**Attachment 1**  
**February 10, 2010**  
**Inspection Findings,**  
**Violations, and**  
**Corrective Actions**

## Industrial Storm Water Inspection Report

Permittee: Lehigh Southwest Cement, Co. (formerly Hanson Permanente Cement)	WDID No. <b>2 43I006267</b>	Date: 2/10/2010
Facility: Lehigh Southwest Cement, Co.	SIC Code: 3241 – Cement, Hydraulic	Receiving Water: Permanente Creek
Facility Address: 24001 Stevens Creek Boulevard; Cupertino (Santa Clara County), California		
Facility Representative(s)/Title(s): Scott Renfrew (Environmental Manager, Lehigh Southwest Cement, Co.), Wilbur Green (Environmental Engineer, Lehigh Southwest Cement, Co.), Henrik Wesseling (Plant Manager, Lehigh Southwest Cement, Co.)		
Additional persons present: None	Inspector(s): Scott Coulson (PG Environmental, LLC)

### Inspection Findings, Violations, and Corrective Actions

Photograph 9 – Pollutant accumulation along the entire inlet portion of Pond 17.

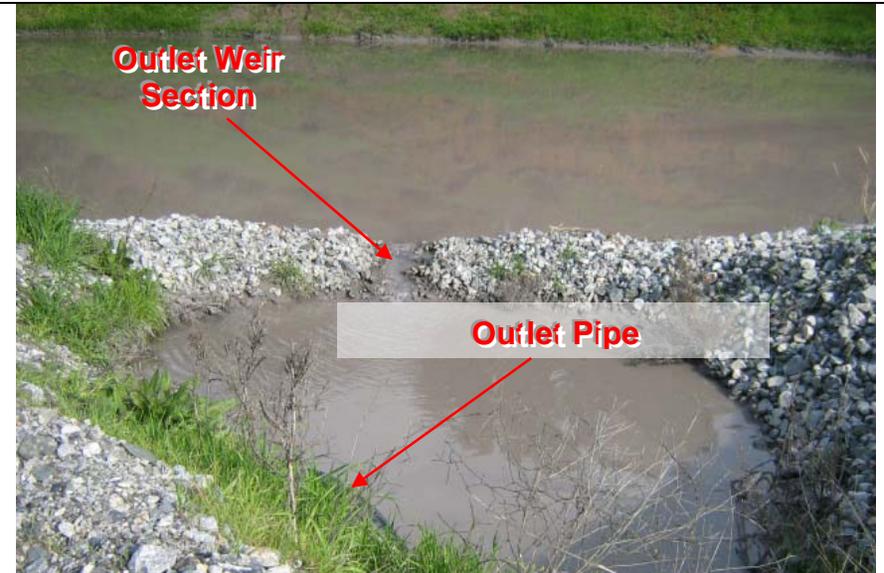
Pollutants were being actively conveyed from the Rock Plant (see attached Photographs 7 and 8) to the Pond 17 inlet. Pollutant accumulation was present along the entire inlet portion of Pond 17, including evidence of a high flow event that had caused the inlet check dams to breach (see attached Photograph 9).

<p>VIOLATION Observed discharge of pollutants to waters of the state</p> <p>REQUIRED CORRECTIVE ACTIONS By <b>April 15, 2010</b>, select, install, implement, and maintain BMPs to meet BAT and BCT to eliminate discharge of pollutants from Pond 17 into Permanente Creek.</p> <p>In order to come into compliance, you may need to implement temporary BMPs and later come back in and implement more permanent measures.</p> <p>Revise the Facility's SWPPP to document updates, and submit a paper and electronic copy to the Regional Water Board.</p>
--

Photograph 14 – The Pond 17 outlet flows to a drainage vault at the toe of the slope.

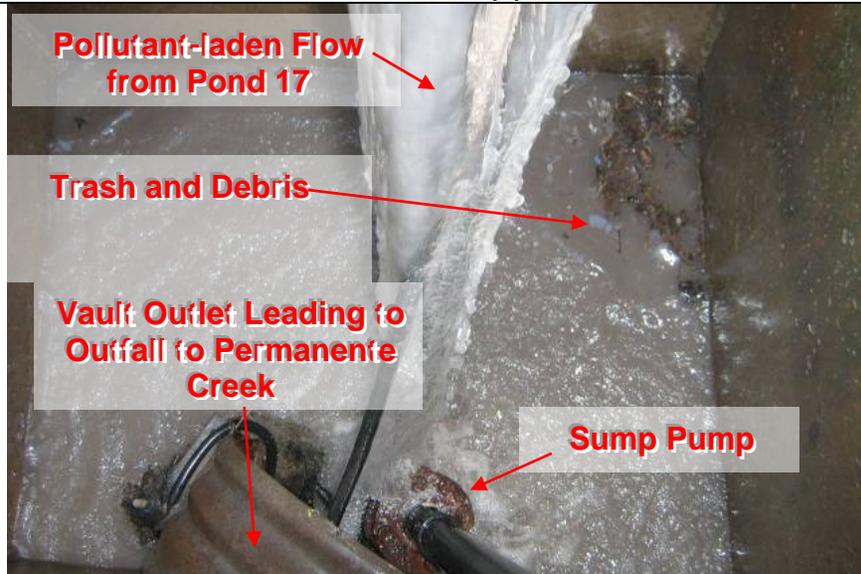
The plumbing configuration down-gradient of the Pond 17 outlet includes an open vault with a sump pump (see attached Photograph 15), and several pipes (see attached Photographs 14 and 16). The Environmental Manager could not explain what the pipes and sump pump are used for. However, the sump pump had the ability to affect the quantity of the facility’s storm water discharges from Pond 17. As

<p><b>VIOLATION</b> Inadequate and non-representative sampling locations</p> <p><b>REQUIRED CORRECTIVE ACTIONS</b> By <b>May 15, 2010</b>, complete a water balance survey of all existing plumbing and drainage flows at the Facility, and update the engineering plans and documents to depict the current plumbing systems and drainage flows on the Facility property. The water balance survey and documentation must address all water onsite, including storm water, process water, and waste water.</p> <p>Provide a paper and electronic copy of the water balance survey to the Regional Water Board.</p> <p>Based on the results of the above-described survey, revise storm water sampling locations, and update Facility maps and monitoring plan accordingly. Provide a paper and electronic copy of all related documents to the Regional Water Board.</p>
---

Photograph 18 – Close-up view of pollutant-laden discharge to Permanente Creek from Pond 17.

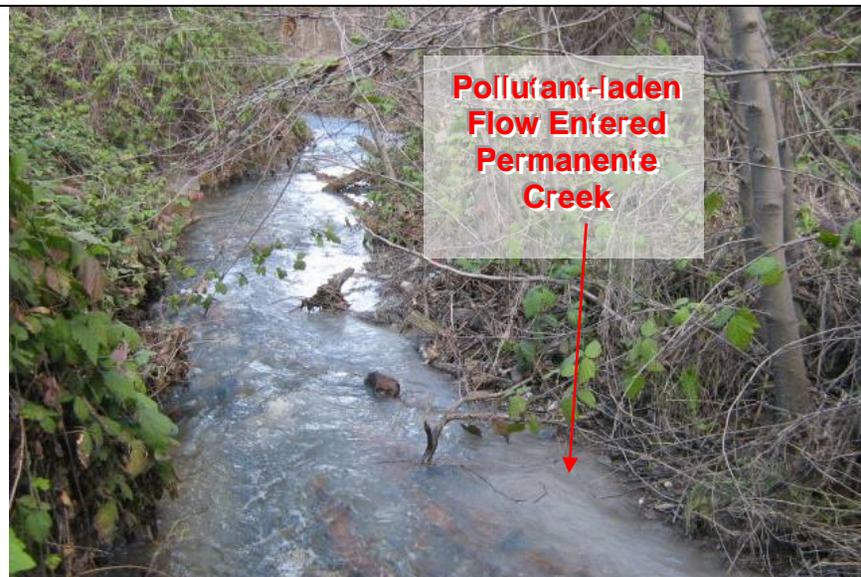
the outlet pipe (see attached Photographs 12 and 13). As specified in Figure 2 of SWPPP 14, the Pond 17 outlet is connected to an outfall to Permanente Creek below Dinky Shed Basin. The Pond 17 outlet flows to a drainage vault (see attached Photographs 14 and 15), which then discharges at the outfall to Permanente Creek. Pollutant-laden flow was observed at the outfall (see attached Photograph 16), and in the Permanente Creek receiving water (see attached Photograph 17 through 19).

Photograph 20 – Sediment conveyed from the Rock Plant Road to the southwestern inlet to Pond 9.

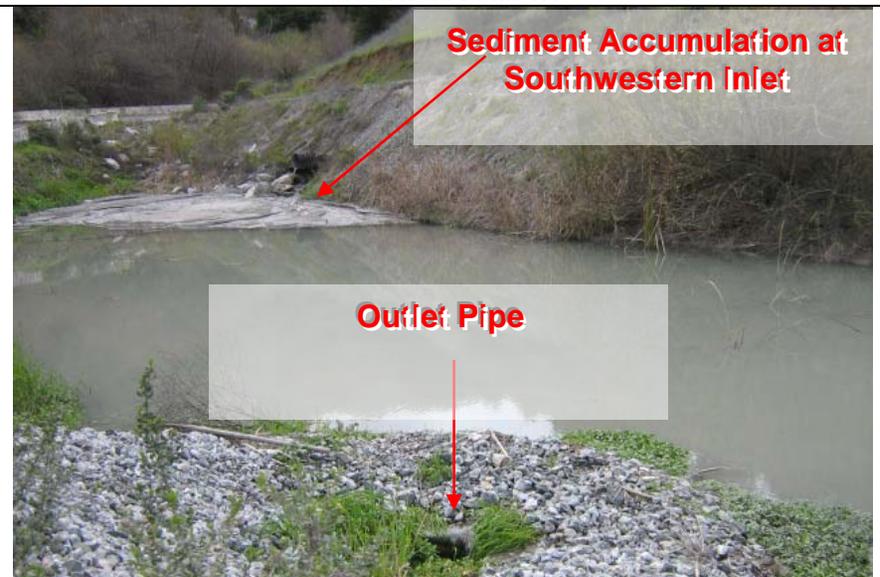
Sediment accumulation was present at the southwestern inlet to Pond 9, and sediment was being actively conveyed from the Rock Plant Road to the southwestern inlet to Pond 9 (see attached Photographs 20 and 21). Sediment-laden water was present in Pond 9, and erosion was observed at the northeastern inlet which lacked flow dissipation BMPs (see attached Photograph 22). As specified in Figure 2 of SWPPP 14, the Pond 9 outlet is connected to an outfall to Permanente Creek, denoted as the SL-17 PD sample collection location (see attached Photographs 23 and 24).

By **April 15, 2010**, select, install, implement, and maintain BMPs to meet BAT and BCT to eliminate discharge of pollutants from Drainage Area D and Pond 9 into Permanente Creek.

Photograph 31 – Slope erosion northwest of Pond 13B.

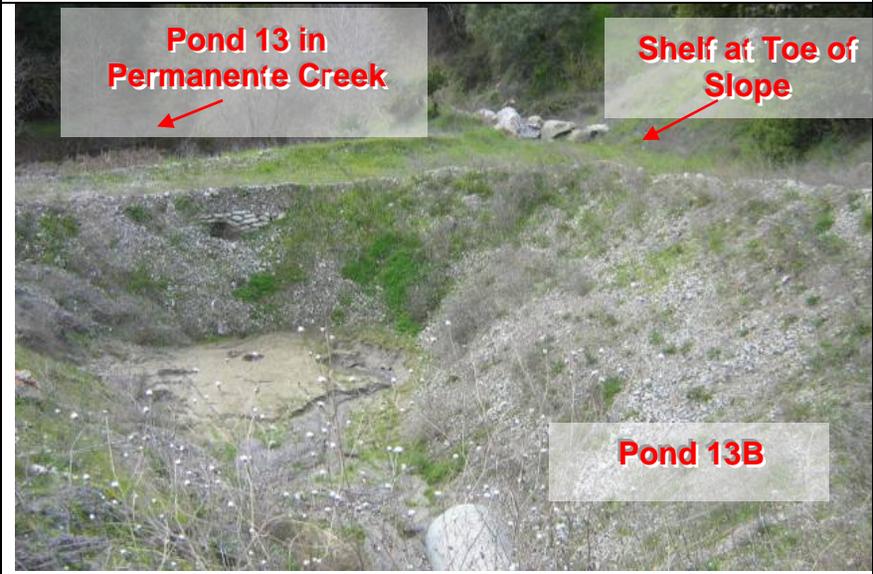
6. The EPA Contract Inspector observed, during the inspection, that adequate BMPs were not implemented to prevent the discharge of sediment from a disturbed slope located northwest of Pond 13B. Evidence of slope erosion and concentrated flow was observed northwest of Pond 13B, including gully formation (see attached Photographs 30 and 31). A shelf at the toe of the slope would prevent flow from entering Pond 13B; instead directing flow events toward Pond 13, an instream sediment control pond (see attached Photographs 30 through 33).

By **April 15, 2010**, select, install, implement, and maintain BMPs to meet BAT and BCT to provide sufficient source control on slope northwest of Pond 13B.

Photograph 34 – Instream sediment control pond denoted Pond 13.

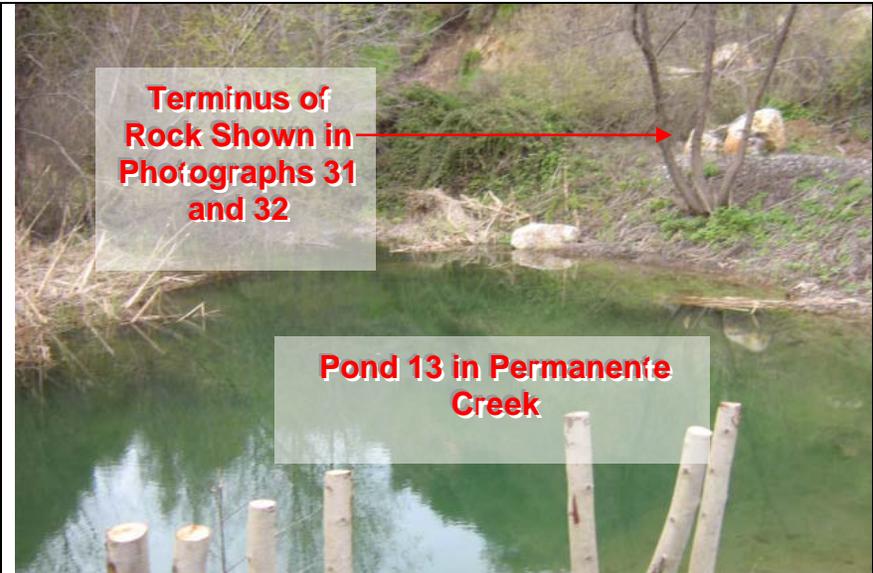
As a result, there was a potential for concentrated flow from the disturbed slope to be conveyed along the shelf at the toe of the slope, and the subsequent discharge of sediment to Permanente Creek at the instream sediment control pond denoted Pond 13 (see attached Photograph 34). Adequate BMPs must be implemented to prevent the discharge of sediment from the disturbed slope to Permanente Creek at the instream sediment control pond denoted Pond 13.

Photograph 35 – Vehicle and equipment maintenance shop in the northeast corner of the Rock Plant.

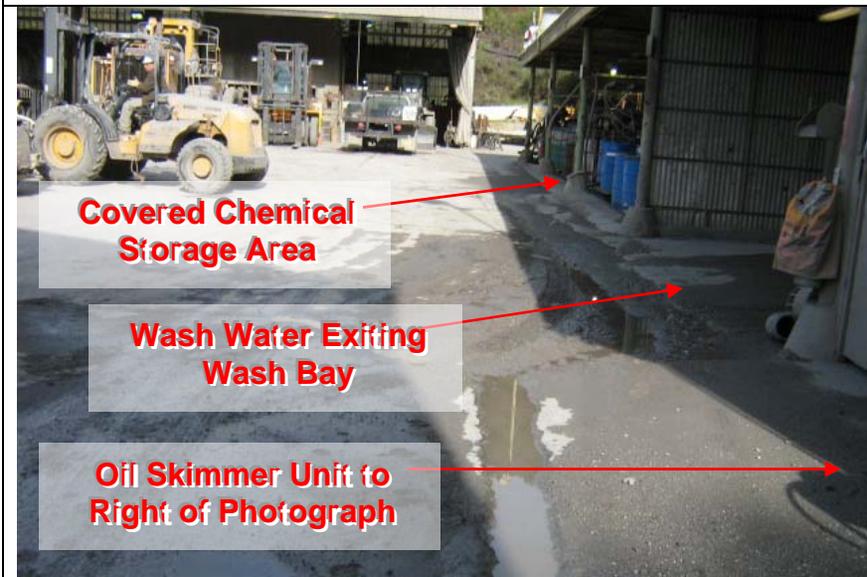
7. The EPA Contract Inspector observed, during the inspection, that adequate Material Handling and Storage BMPs were not implemented to minimize exposure of significant materials to storm water at the vehicle and equipment maintenance shop located in the northeast corner of the Rock Plant (see attached Photograph 35). Automotive lubricants and other chemicals were stored in standing water at the chemical storage area (see attached Photographs 36 through 39).

**REQUIRED CORRECTIVE ACTIONS**  
By **April 15, 2010**, select, implement, and maintain adequate material handling and storage BMPs.  
Identify all non-storm water discharges.  
Eliminate prohibited non-storm water discharges.

Photograph 43 – View of oily residues near the skimmer unit.

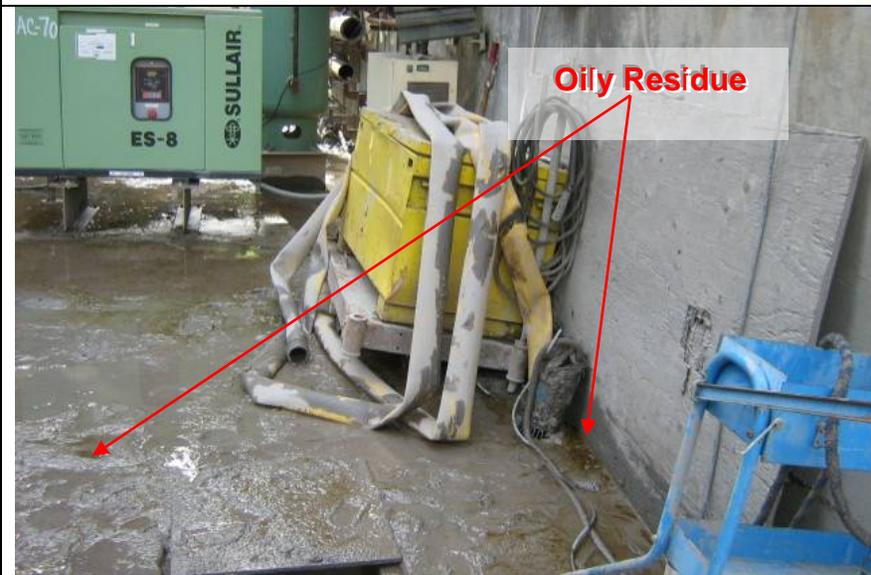
Section 4.4 of SWPPP 14 did not identify the vehicle and equipment wash bay as a potential non-storm water pollutant source. Table 5-2 of SWPPP 14 specifies “do not permit wash water to...runoff onto ground surface...recycle wash water,” but this BMP had not been adequately implemented onsite (see attached Photographs 35 and 41). Oily residues were present throughout the area adjacent to the skimmer (see attached Photographs 42 through 44).

**REQUIRED CORRECTIVE ACTIONS**  
By **April 15, 2010**, select, implement, and maintain adequate material handling and storage BMPs.  
Identify all non-storm water discharges.  
Eliminate prohibited non-storm water discharges.

Photograph 47 – Drum of acidic descaler stored in standing water.

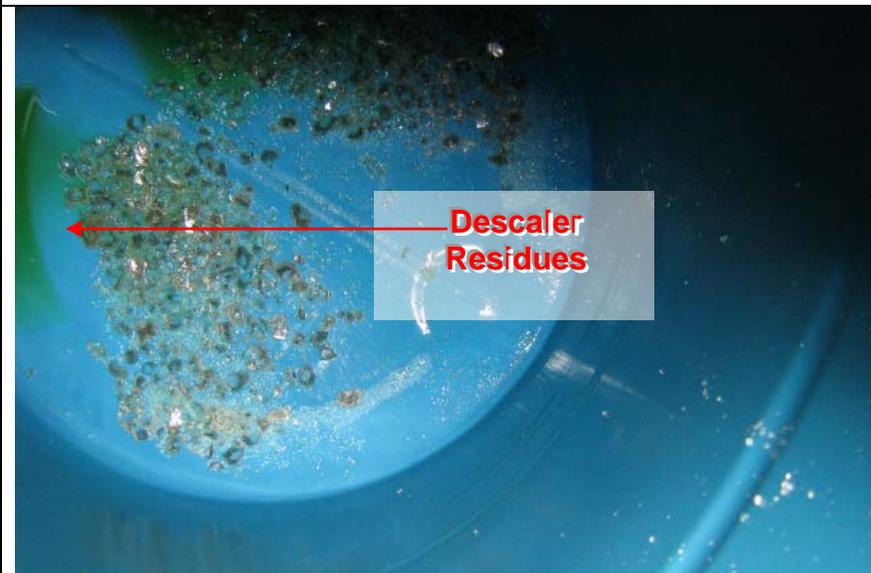
water drains to the Pearl Harbor lift station. This drainage connection was not confirmed during the inspection. A drum of acidic descaler was stored in standing water at the vehicle and equipment washing area (see attached Photographs 46 and 47). Standing water has the potential to increase storm water contact with pollutants.

<p><b>VIOLATION</b> Inadequate Material Handling and Storage BMPs for containment of cleaning materials at vehicle and equipment washing area near Pearl Harbor Lift Station</p> <p><b>REQUIRED CORRECTIVE ACTIONS</b> By <b>April 15, 2010</b>, select, implement, and maintain adequate material handling and storage BMPs.</p> <p>Revise the Facility’s SWPPP to document updates, and submit a paper and electronic copy to the Regional Water Board.</p>
---

Photograph 50 – Petroleum-based automotive lubricants and other chemicals stored in standing water.

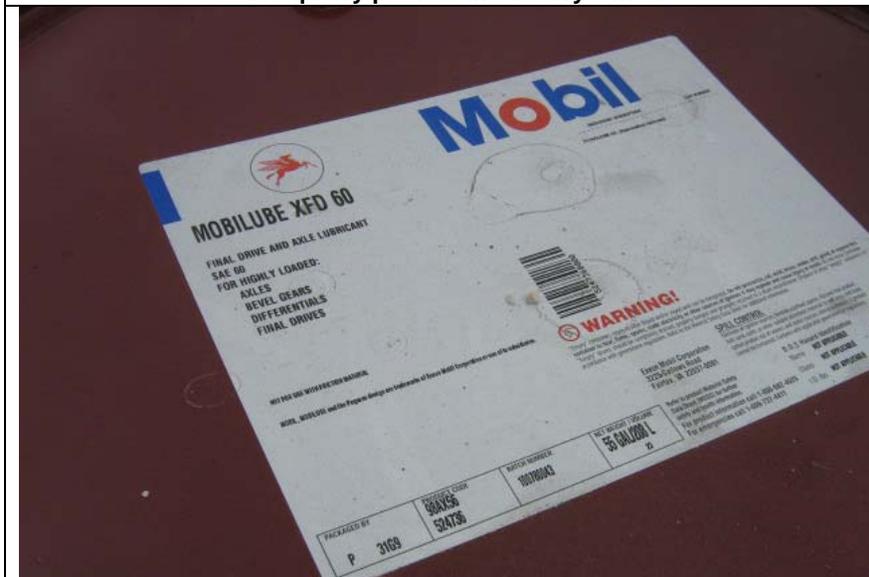
Full drums of petroleum-based automotive lubricants were stored in standing water at the concrete pad (see attached Photographs 50 through 52). In addition, an open waste container used for hazardous wastes (e.g., oil soaked rags, etc.) had accumulated standing water inside (see attached Photographs 53 and 54). As a result of these material storage practices and the standing water near the capacity of the concrete pad (see attached Photographs 49 and 55), there was a potential for the contribution of pollutants to storm water and the subsequent release of pollutants from the concrete pad.

By **April 15, 2010**, select, implement, and maintain adequate material handling and storage BMPs.

Photograph 59 – View of slope failure at intersection of access road and Upper Quarry Road.

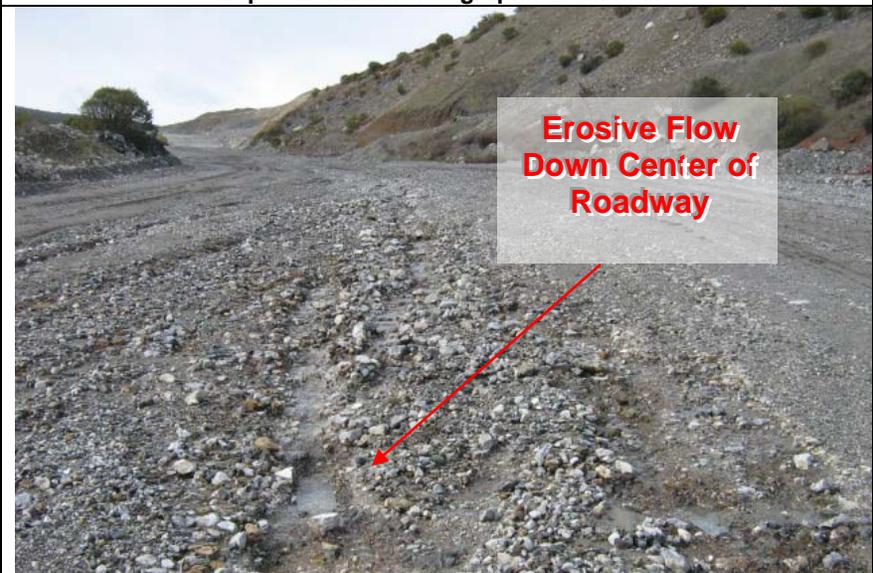
The slope near the intersection of Upper Quarry Road and an access road leading northeast, showed erosion, including gully formation (see attached Photographs 56 and 57), fine sediment accumulation at the toe of the slope (see attached Photograph 58), and slope failure (see attached Photograph 59).

By **April 15, 2010**, install erosion control BMPs to protect road and associated cut and fill slopes from erosion. In order to come into compliance, you may need to implement temporary BMPs and later come back in and implement more permanent measures.
